APPLICATION NO.	FILING DATE	FIRST NAMED INVENTOR	ATTORNEY DOCKET NO.	CONFIRMATION NO.
10/501,091	07/09/2004	Takashi Suzuki	042565	3053

Office Action Summary	Application No. 10/501,091	Applicant(s) SUZUKI ET AL.	
	Examiner Noah C. Hawk	Art Unit 3636

DETAILED ACTION

McKenney, Figure 1

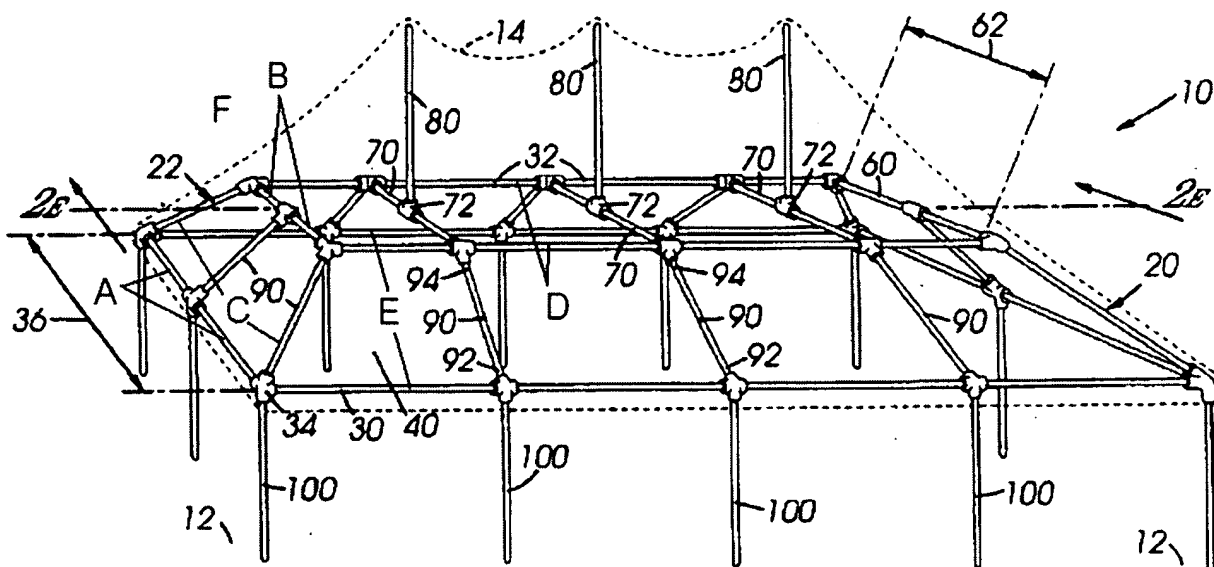
- a. Regarding Claim 1, McKenney teaches a tent having an awning roof with left and right upright trapezoidal sides, a flat zenith (best seen in Figure 2b) and front and rear inclined faces as well as trapezoidal frames (formed on the ends by members A, B and C) forming left and right sides and four bridge beams (D, E) extending horizontally between the trapezoidal frames.

- b. Regarding Claim 3, McKenney further teaches reinforcing members (80) arranged to have a projecting ridge on the zenith.
- c. Regarding Claim 4, McKenney further teaches a convex portion (best seen in Figure 1) provided in the zenith.

- d. Regarding Claim 5, McKenney further teaches that the framework comprises two ridge beams (D), two side beams (B, shown only on one side of the tent), two pole plates (E), two end plates (A, shown only on one side of the tent) and four rafters (C, shown only on one side of the tent), all of which are made of metallic pipes (see McKenney, Column 4, lines 66-67).
